**INVER GROVE HEIGHTS  
PLANNING COMMISSION AGENDA**

**TUESDAY, JULY 16, 2013 – 7:00 p.m.  
City Council Chambers - 8150 Barbara Avenue**

**PLANNING REPORT  
CITY OF INVER GROVE HEIGHTS**

**CASE NO:** 13-30PR

14' x 19' deck and ramp area

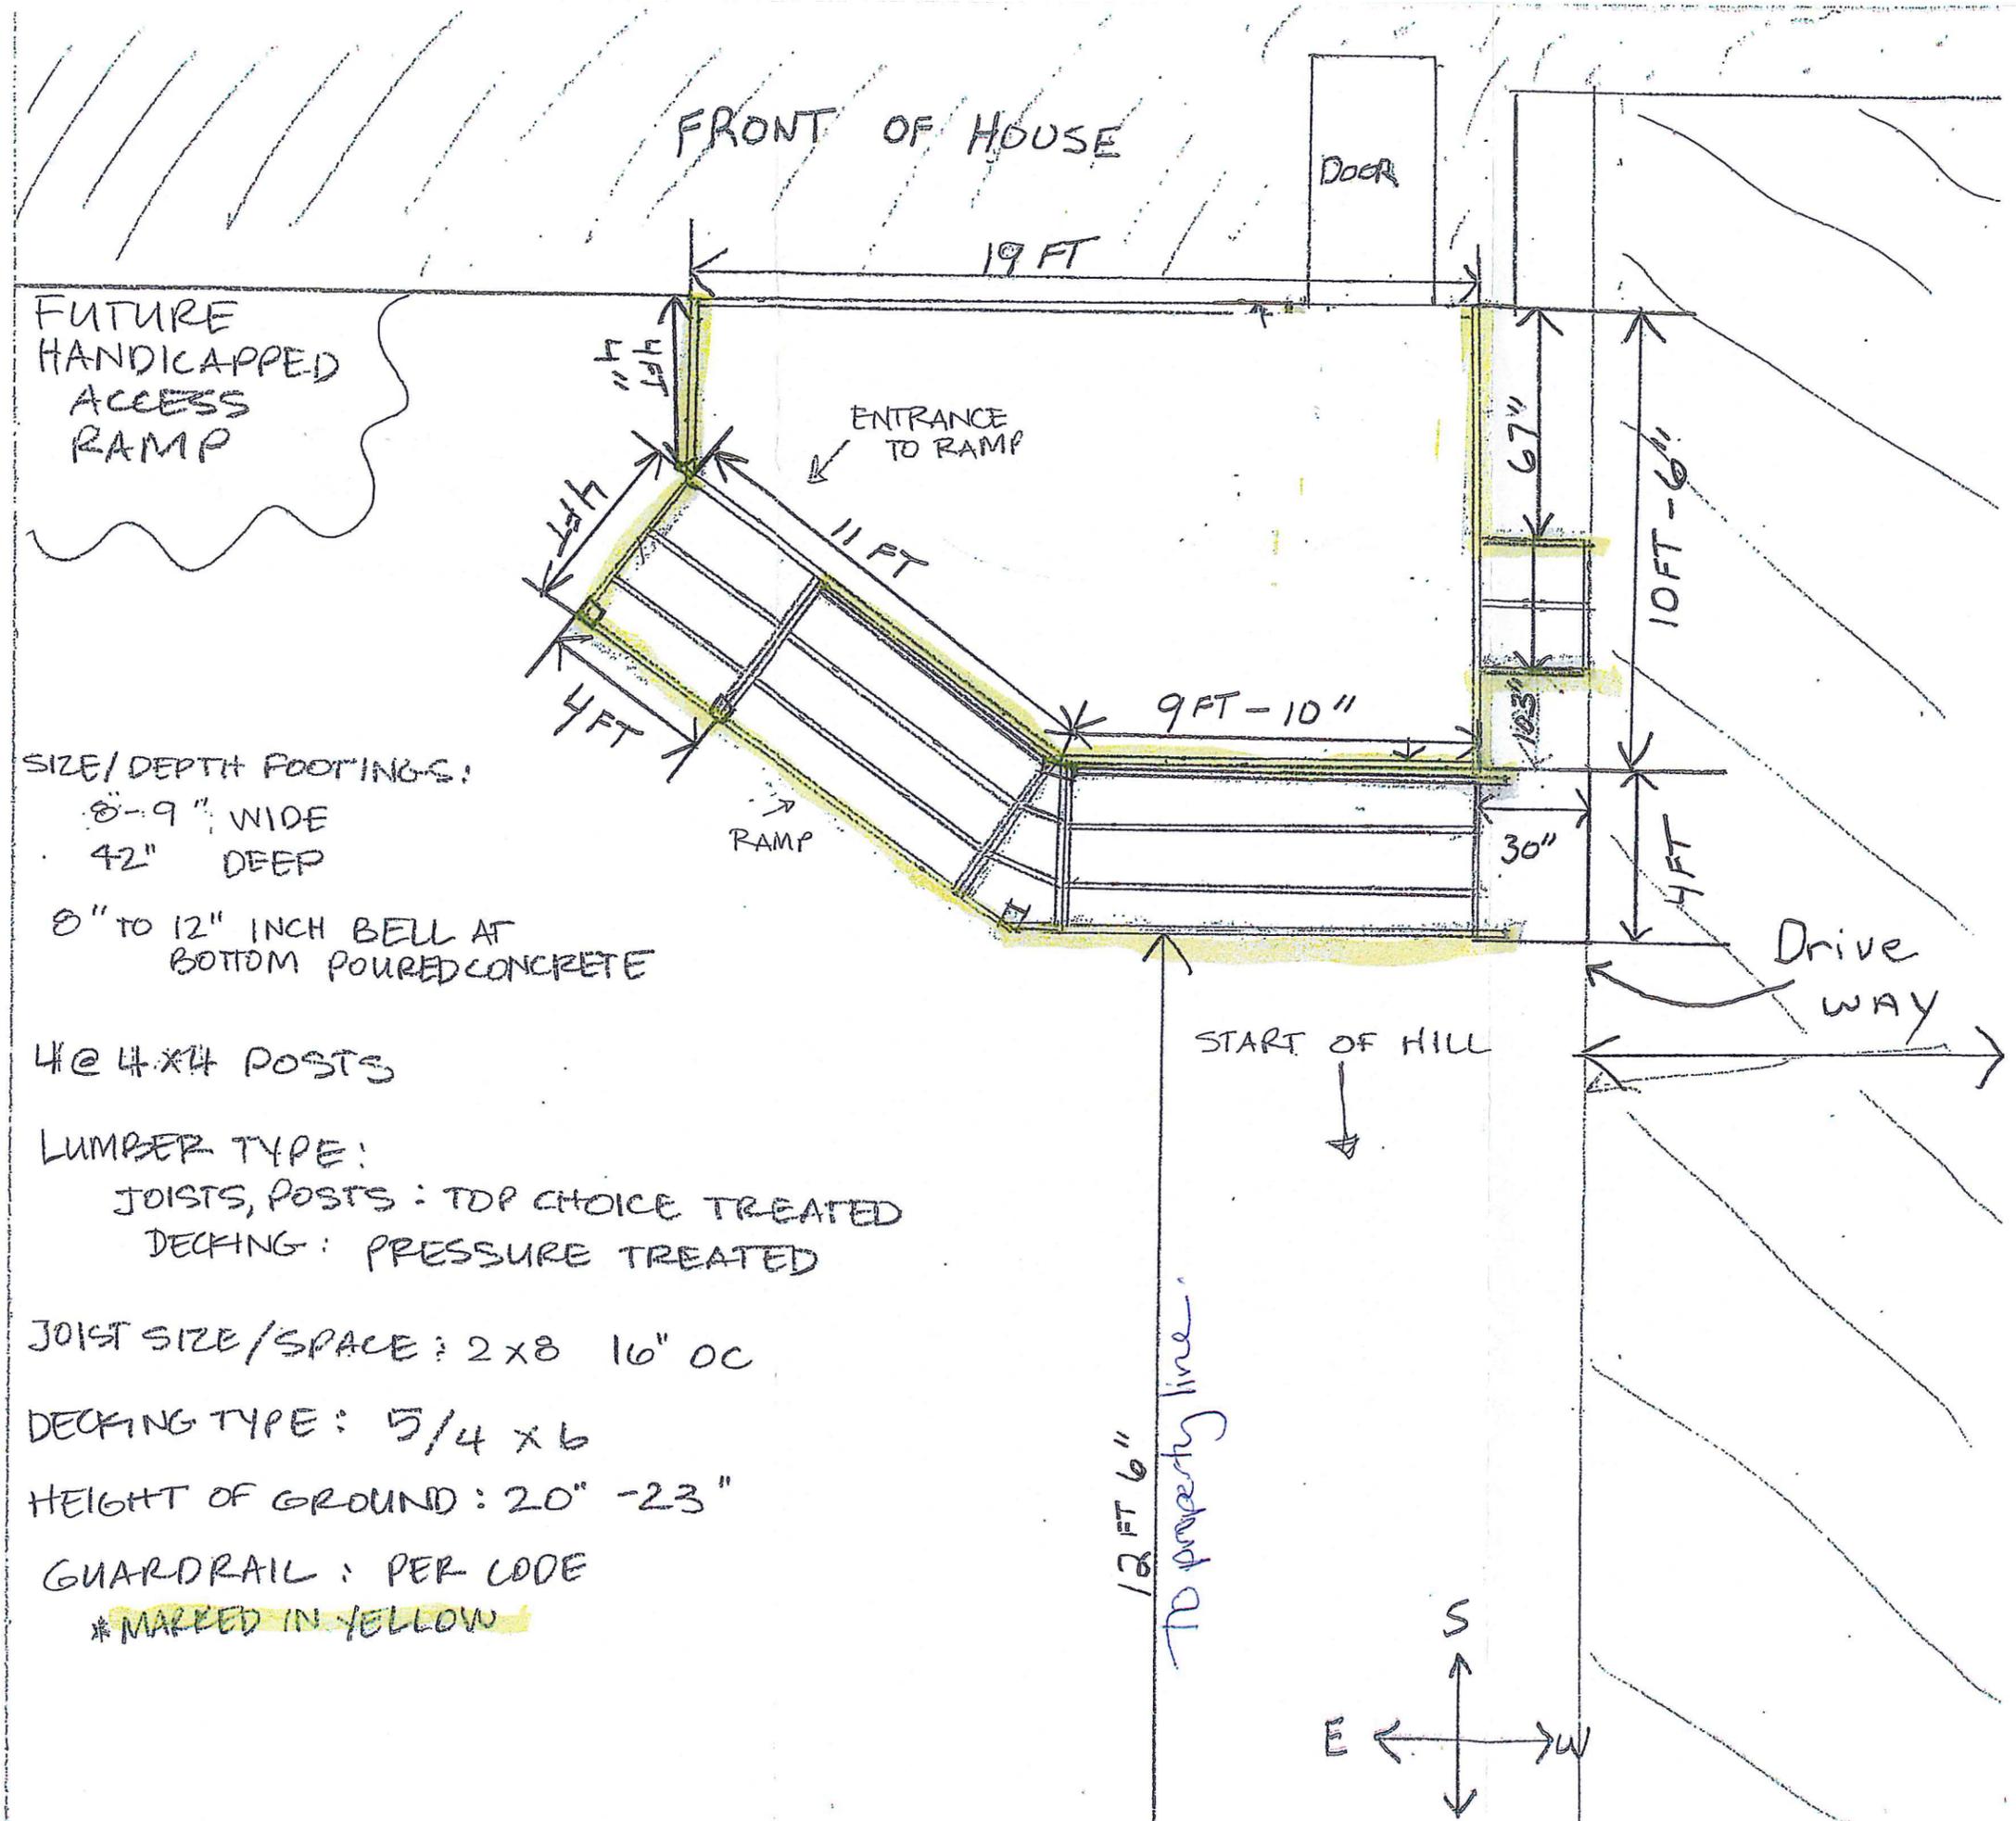
The code allows for a 24' front yard setback (six foot encroachment) for uncovered access ramps and decks. Allowing an encroachment greater than this could set a precedent for other front yard additions. The request is in harmony with the intent of the comprehensive plan as the lot is being utilized as residential.

Setback standards are not precluding the homeowner from reasonable use of the property. The front addition extends beyond what was envisioned when the code was amended to allow open decks or ramps on houses to encroach up to six feet. A typical front entry stoop must be at least 3' x 3' per building code. Installing a ramp next to a three foot landing with another three feet to accommodate the proposed stairs would seem reasonable and could meet the variance criteria. Beyond this creates further encroachments into the front yard setback which is established to maintain a straight visual sight line along the streetscape and to keep structures back from the street.

The zoning code has a special provision allowing uncovered decks and ramps to encroach within the front yard setback. The size of the proposed deck may be considered a convenience to the applicant, not a practical difficulty.

One of the functions of setback requirements is to maintain consistency of structure placement and aesthetic qualities from street and neighboring views. The proposed deck and ramp would be one of the only front yard encroachments along 71<sup>st</sup> Street. Because the addition is an open deck and ramp, it would not have the same effect as if an enclosed addition was being proposed. Staff has felt front yard encroachments can have a greater impact on the character of the neighborhood compared to side or rear encroachments.

Staff believes the applicant did not identify practical difficulties to comply with the ordinance. For the reasons listed in Alternative B staff is recommending denial of the proposed request. Staff would support a 17' setback from the front lot line which would allow a six (6) foot uncovered deck encroachment along with the four foot wide proposed ramp with the condition listed in Alternative A.

**GRADING,  
DRAINAGE, AND  
EROSION CONTROL  
PLAN**

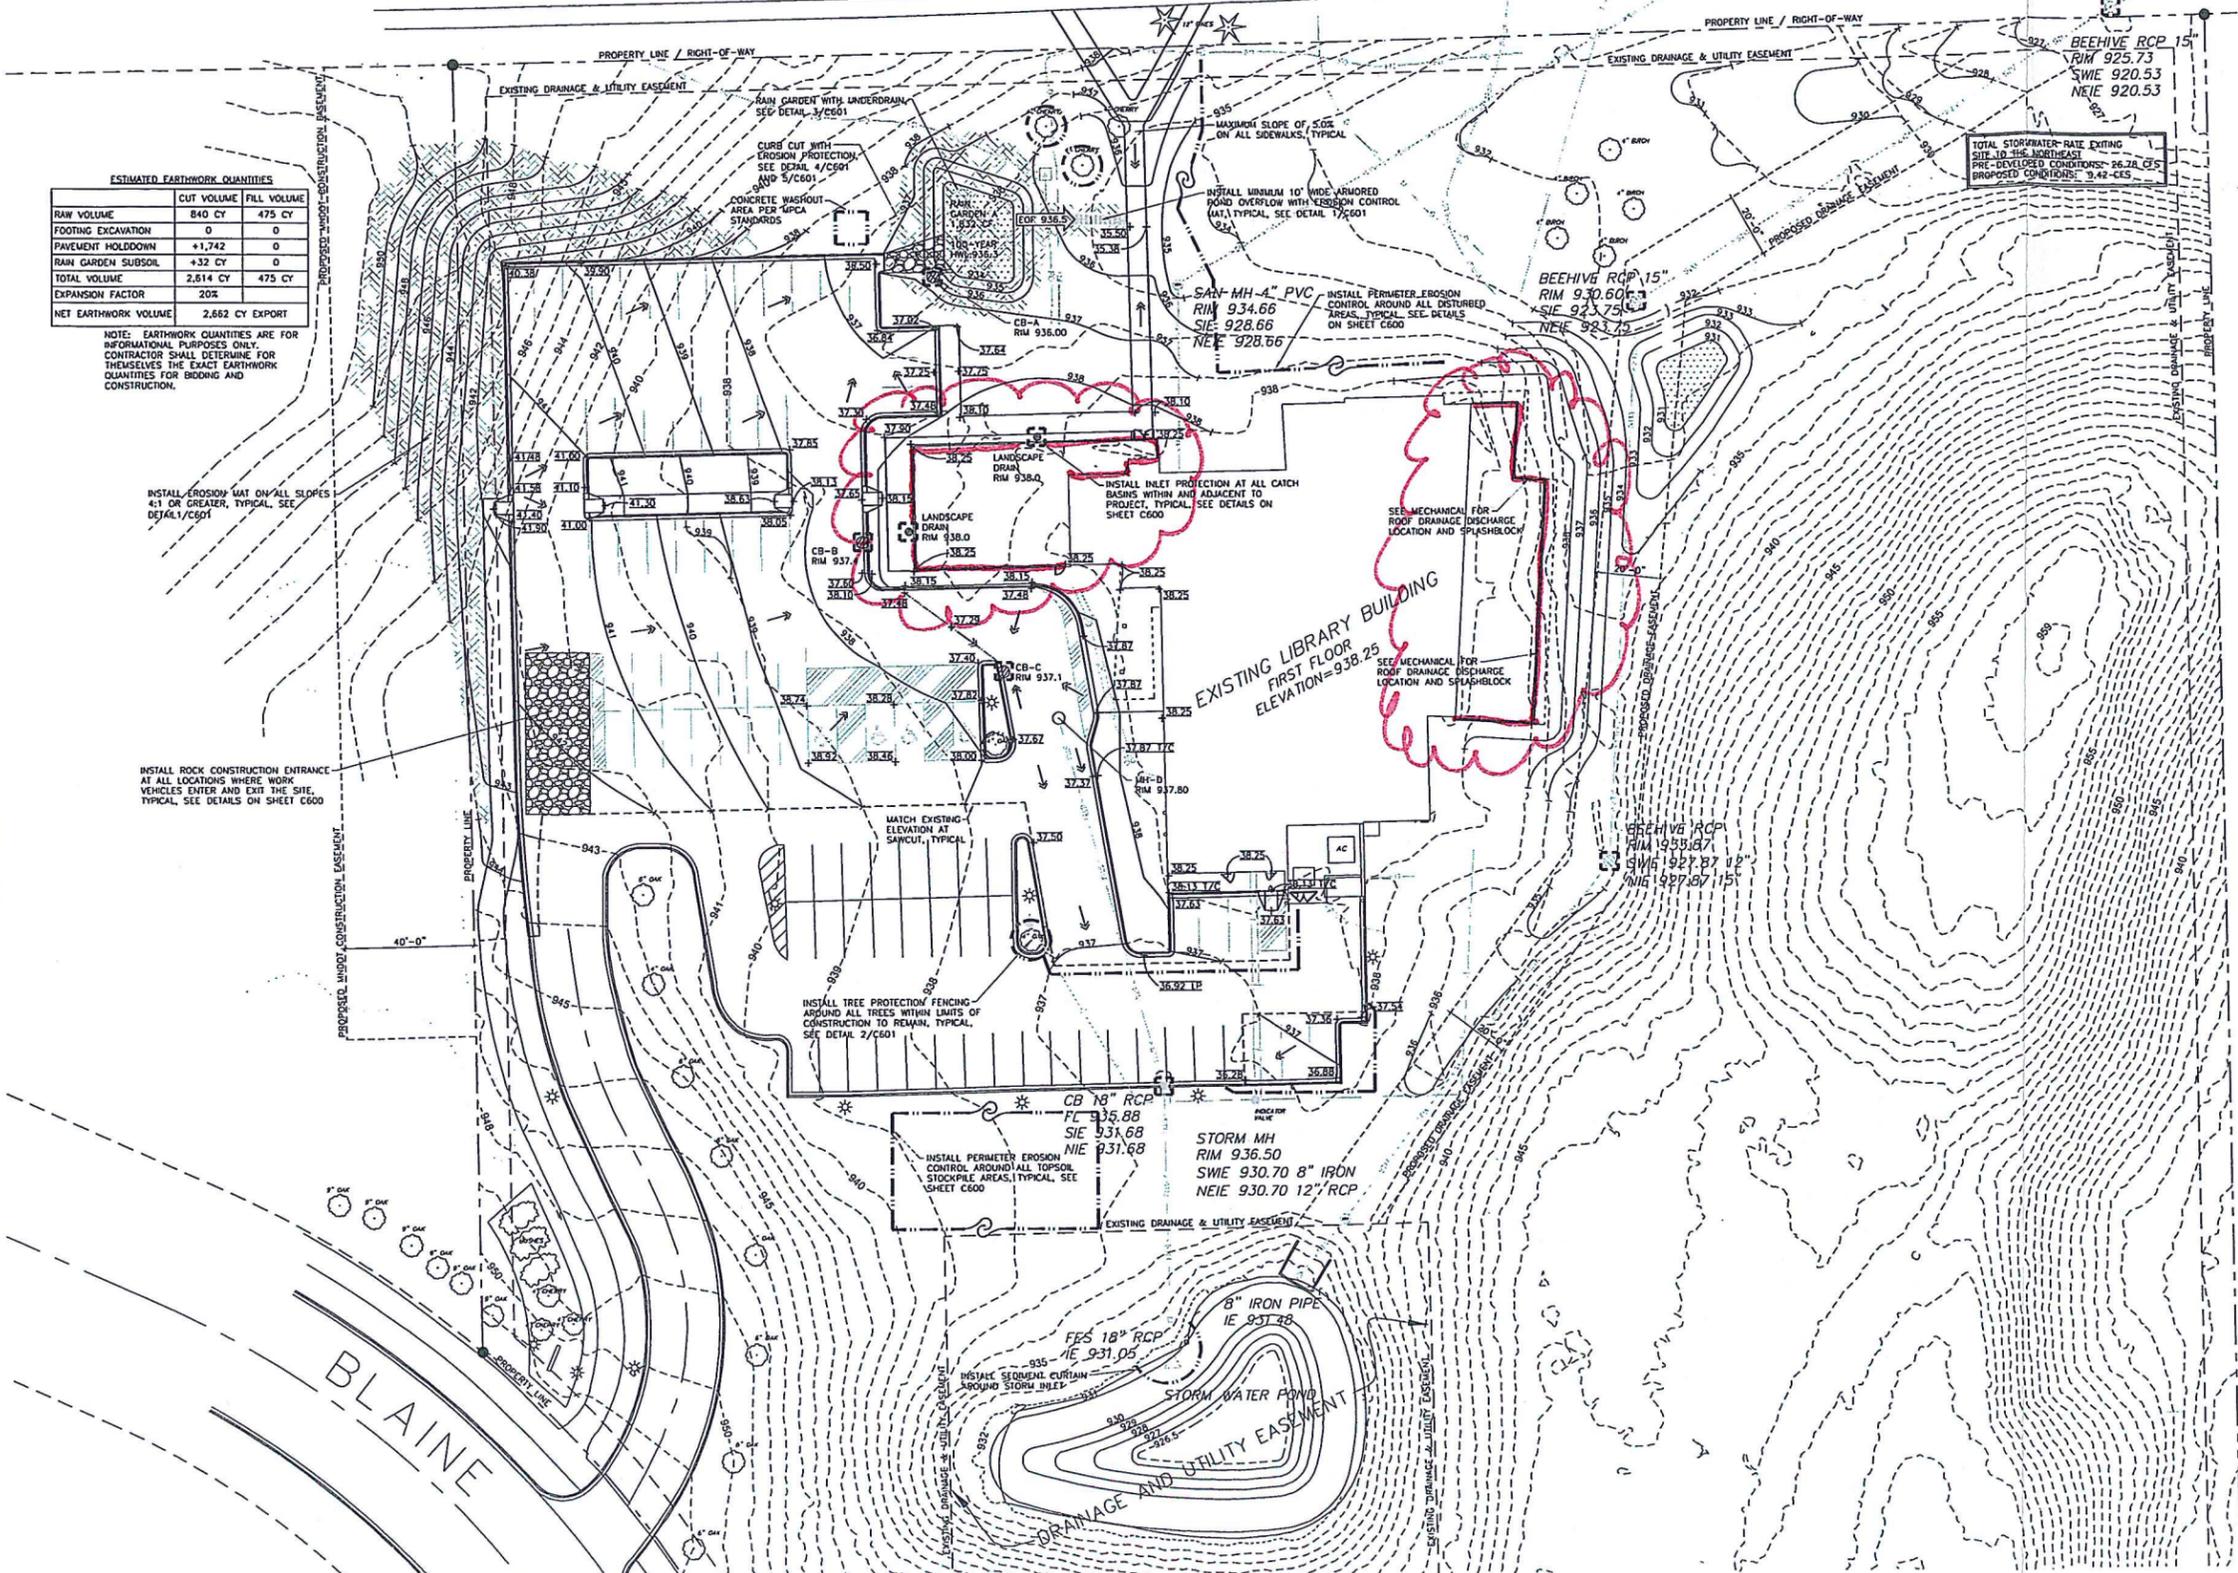
Grading and Drainage. Engineering has reviewed the plans and has been working with the applicant on storm water and grading requirements. Engineering has made some recommendations on conditions that should be added to the approval; these conditions are included in the list of conditions at the end of this report. Final site, grading, storm water management, and erosion control plans shall be approved by the City Engineer.

5. The developer shall meet all the conditions outlined in the City Engineers review letters and subsequent correspondence. Prior to commencement of any grading, the final grading, drainage and erosion control, and utility plans shall be approved by the City Engineer.
